Horizon House West Tower

Design Review Board Recommendation | August 12, 2024

Project Address
900 University Street

EDG RESPONSE | TOP OF TOWER MASSING

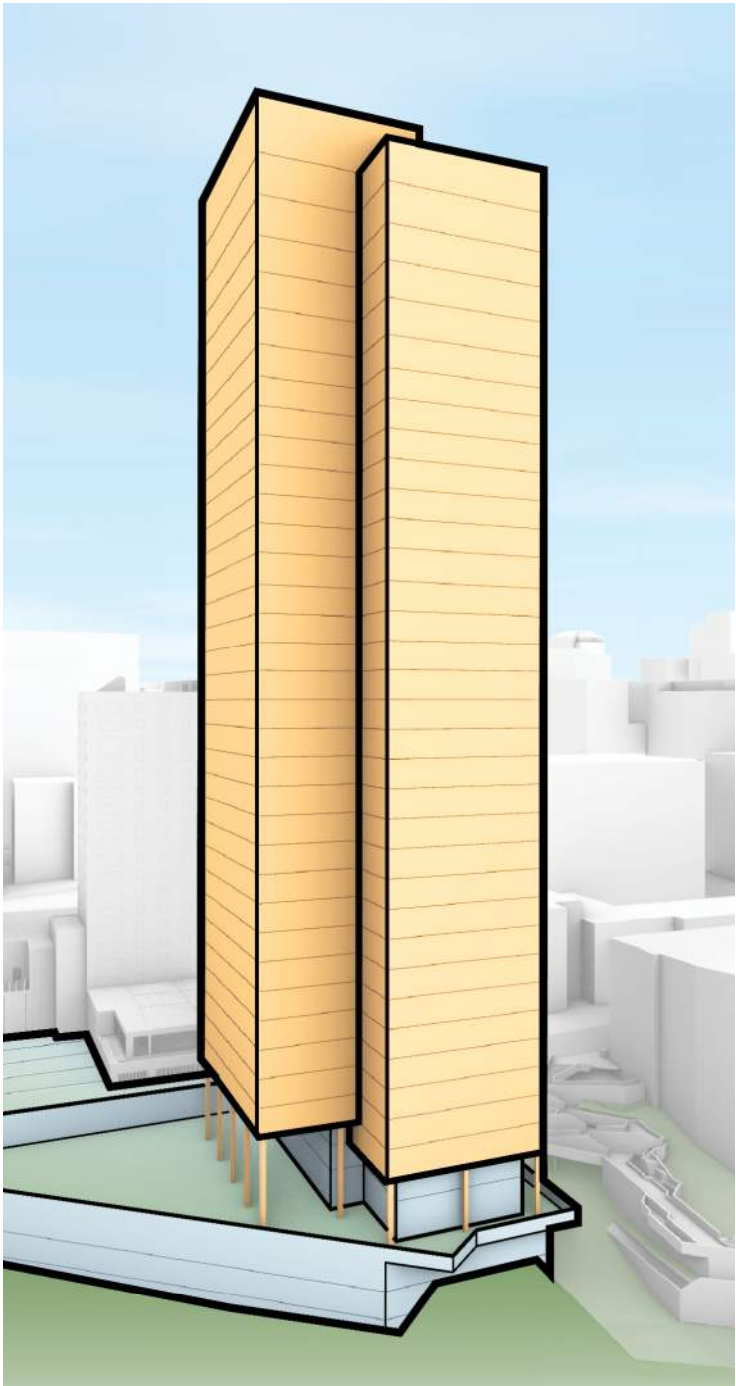
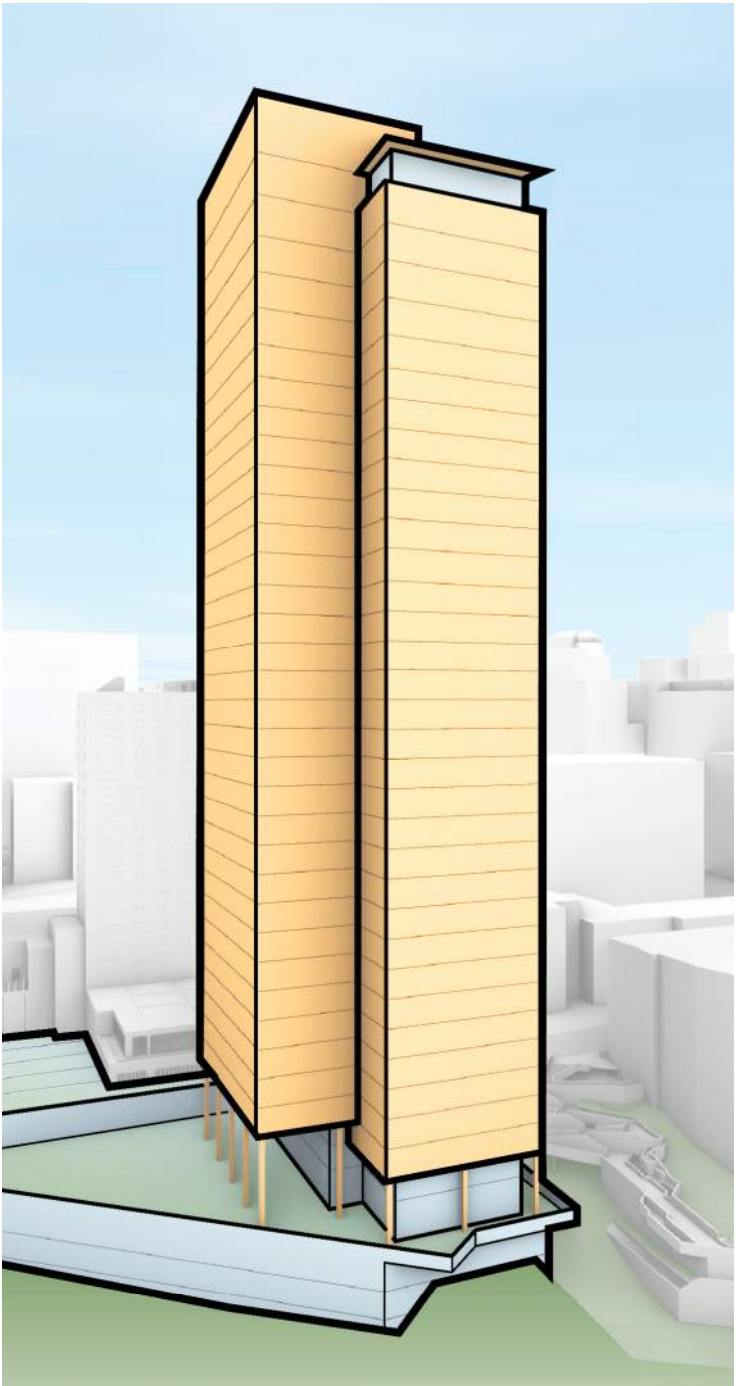
2B The Board also expressed concern regarding the limited height difference between these two elements at the top of the tower. The Board agreed that the distinction of the two masses should be strengthened through some combination of height difference and architectural expression of the two elements at the top of the tower. The Board stated that if additional overall height were proposed as part of the solution that they would almost certainly support it. (DC2-A, CS2-D, CS2-B)

Informed by the EDG process, the revised tower massing is intended to increase the perceived height difference between the two distinct volumes. This is done by indenting the building envelope at Level 33 of the south tower volume. A roof canopy caps that indentation to help define this void and improve the legibility of the height difference and provide cover for occupiable exterior space at Level 33.

EDG RESPONSE | TOWER CONTEXT

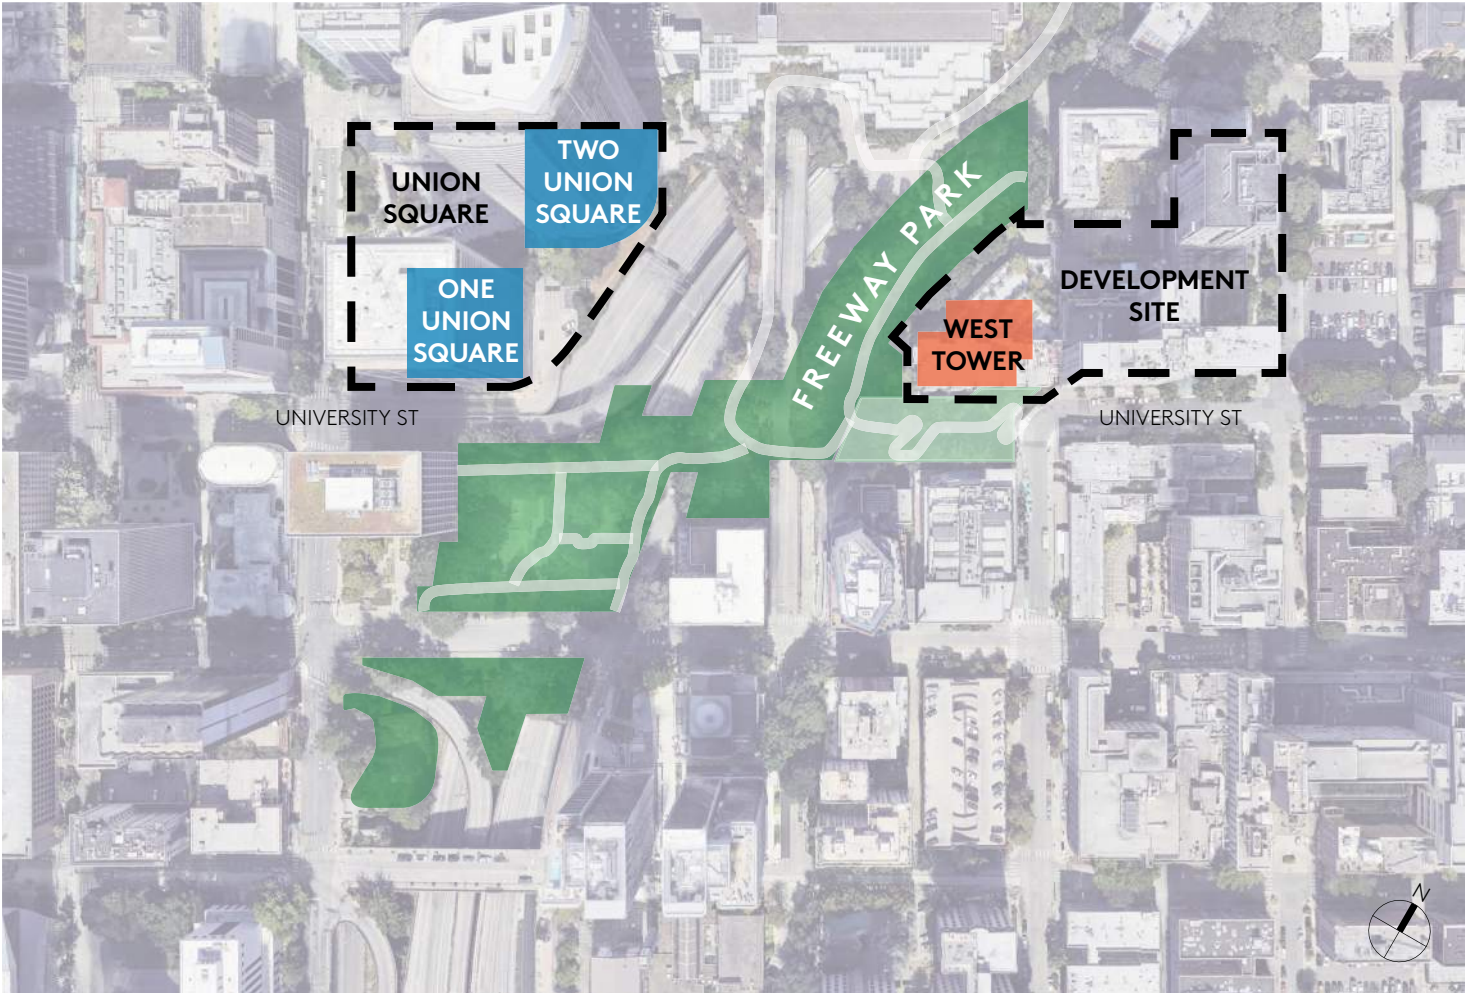
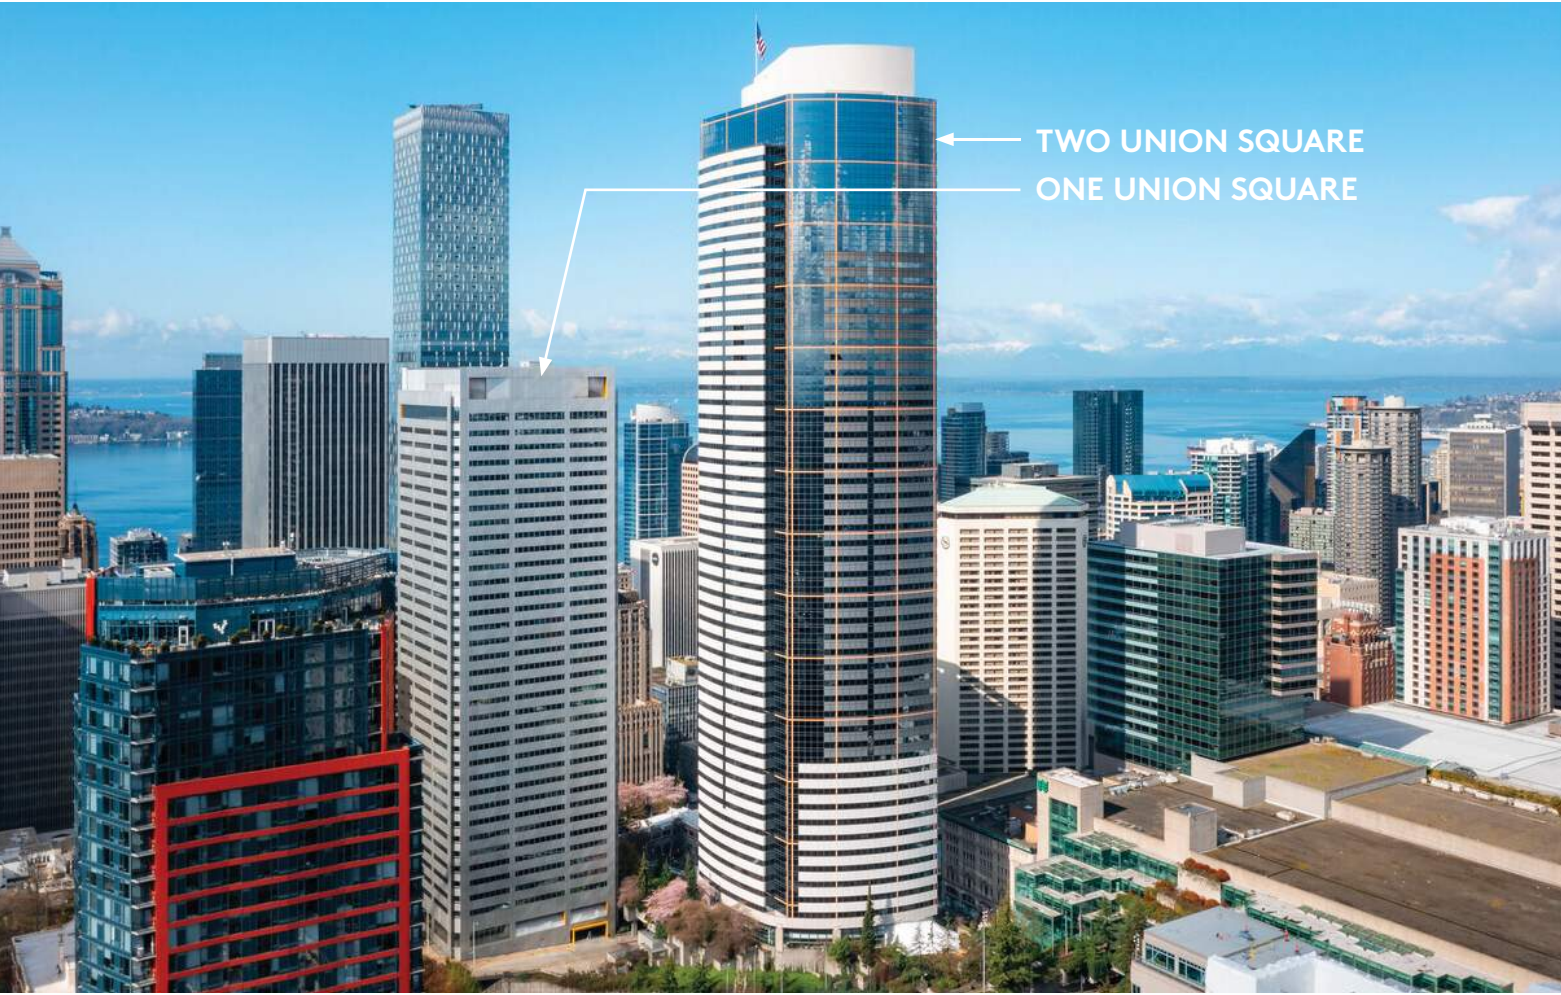
2C The Board considered the proximity of this project to the existing tower across Freeway Park (2 Union Square) and how this new proposed tower would respond to that context. The Board asked that perspective views including both towers be provided in the Recommendation packet, from both the Park and nearby streets.(CS2, CS3).

Union Square, directly across Freeway Park from the proposed West Tower, communicates a scale and materiality consistent with the grand commercial office structures of Downtown. The design intends to relate to these towers by color choice but also provide a counterpoint in scale & detail emphasizing the transition between downtown office towers and the residential First Hill Neighborhood. The choice of a lighter color further supports a precedent for light color buildings directly adjacent to the park providing a bright neutral backdrop to the verdant colors of Freeway park. See next page for diagrams demonstrating the proposed design adjacent within view of the Union Square Towers.

EDG RESPONSE | SECONDARY ENTRY ARCHITECTURAL CHARACTER

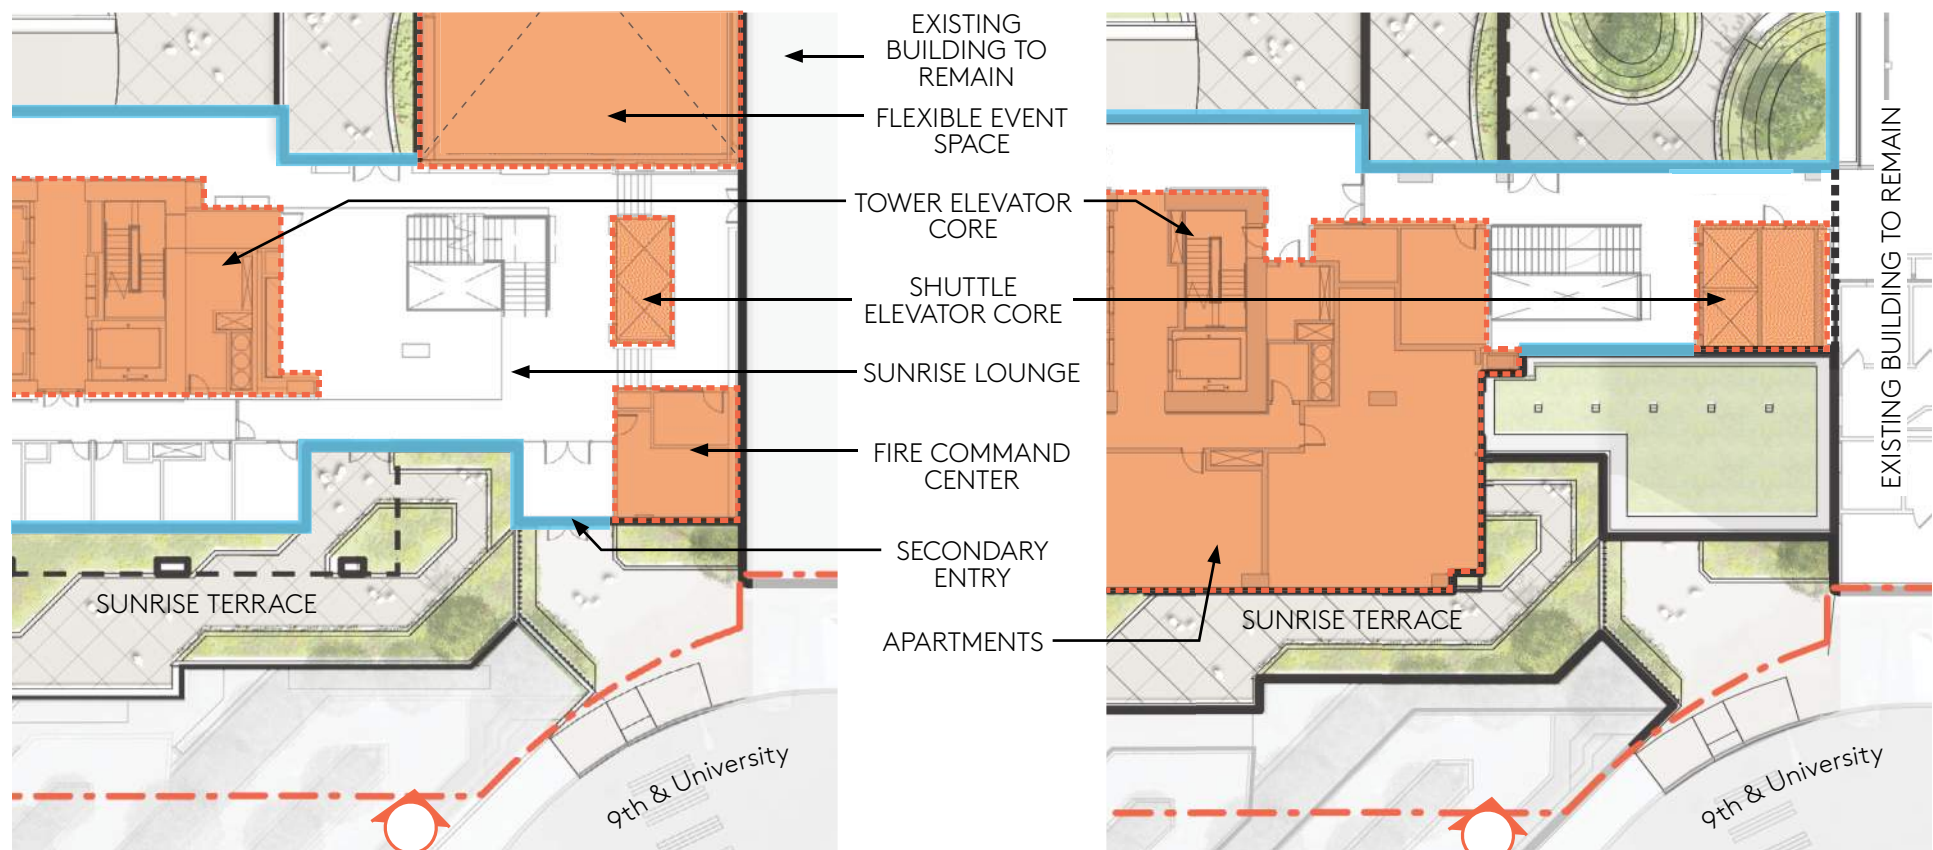
3D The Board discussed the architectural character of the two-story element containing the entry on University Street and agreed that this should be designed to feel open and welcoming. The Board provided guidance that this articulation should be distinct enough from the adjacent towers ("transparent and blazing" was offered by one Board member) to stand out as a separate element, which will help reduce the project's overall perceived scale. (PL3-A, DC2-A)

4A The Board discussed the location of the new building entrance and how it would connect to the Piggot Corridor and Freeway Park. The Board noted the entrance's lack of architectural distinction in the EDG packet. Echoing public comment, the Board agreed that connections to Freeway Park and to the public realm were critical to the success of the project and provided guidance that this entry be appropriately scaled, distinctly expressed and clearly legible. (CS2-B, PL1-B, PL3-A)

Informed by the EDG comments, the proposed design intends to balance the need for the secondary entry to be both welcoming and understated as not to compete with the existing main building entry to the East on University Street. The use of glazing at either side of the building envelope on Level B1 and Level 1 provide a welcoming transparent facade allowing a pedestrian to see through the building while walking North on 9th Ave. The scale of exterior materials and horizontal massing assist in communicating a private residential entry by reducing its perceived massing and distinguishing it as a separate elements from the adjacent towers.

Informed by the First Hill Public Realm Action Plan, the secondary entry and sunrise terrace are intended to provide additional activity & eyes on that street at the corner of University St and 9th Ave. This shall benefit the long range plan for this intersection which includes additional public amenity space to the south of the project site.

EDG RESPONSE | WIND IMPACT

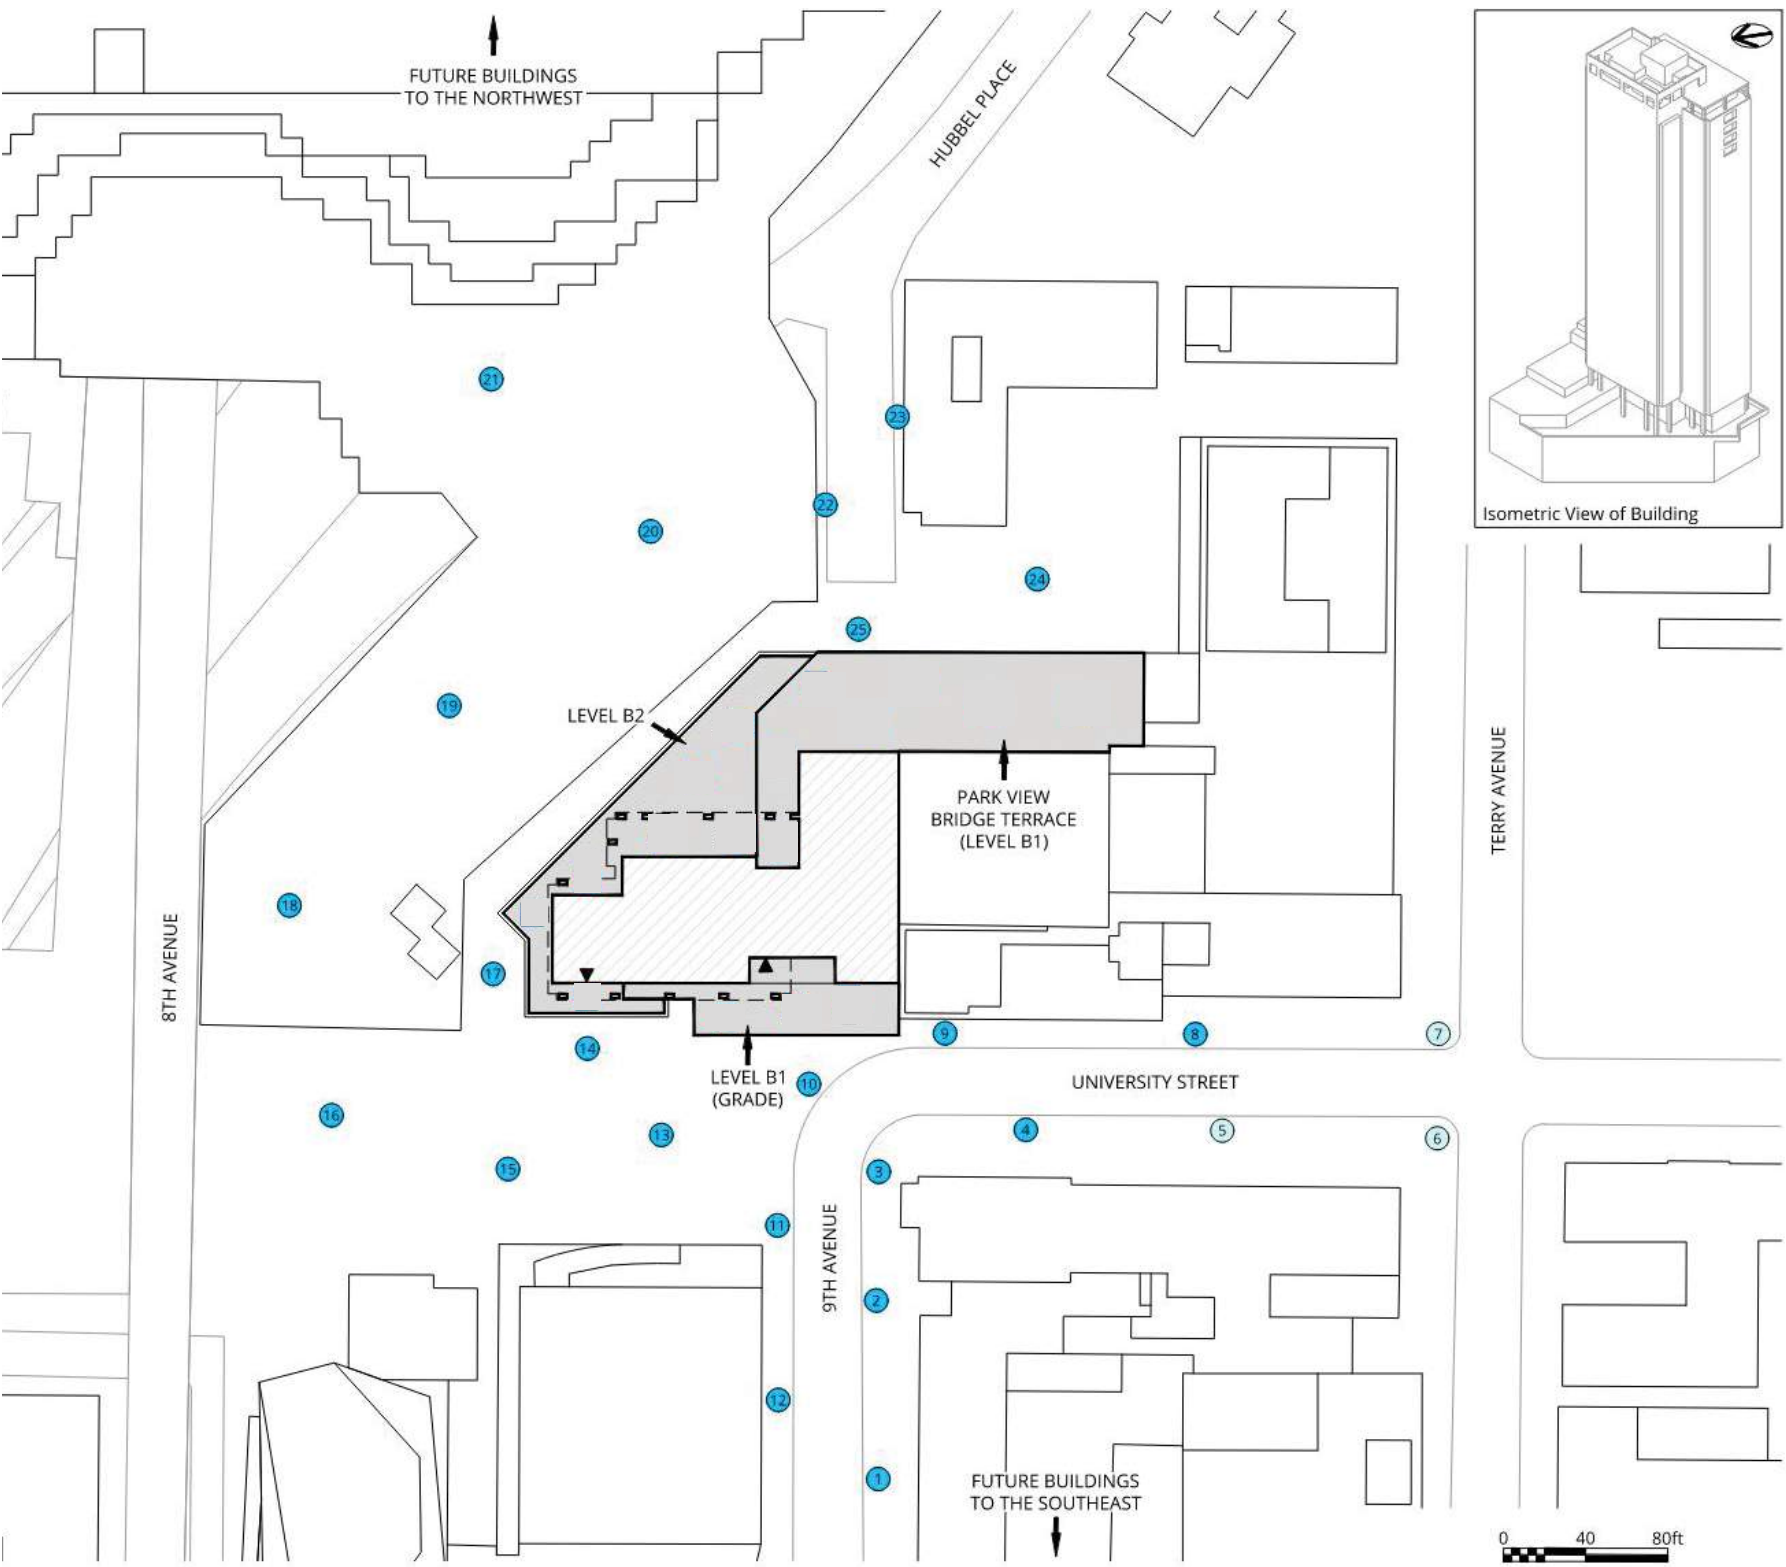
iv. the potential for wind to impact pedestrian areas.

A pedestrian wind comfort study was professionally performed to understand the project impacts on the adjacent pedestrian environment. The study found that the project does not present any wind conditions that predict discomfort for adjacent pedestrian spaces and may not be noticeably different from existing conditions today. The graphics shown to the right represent the worst-case wind scenario during a 12-month period.
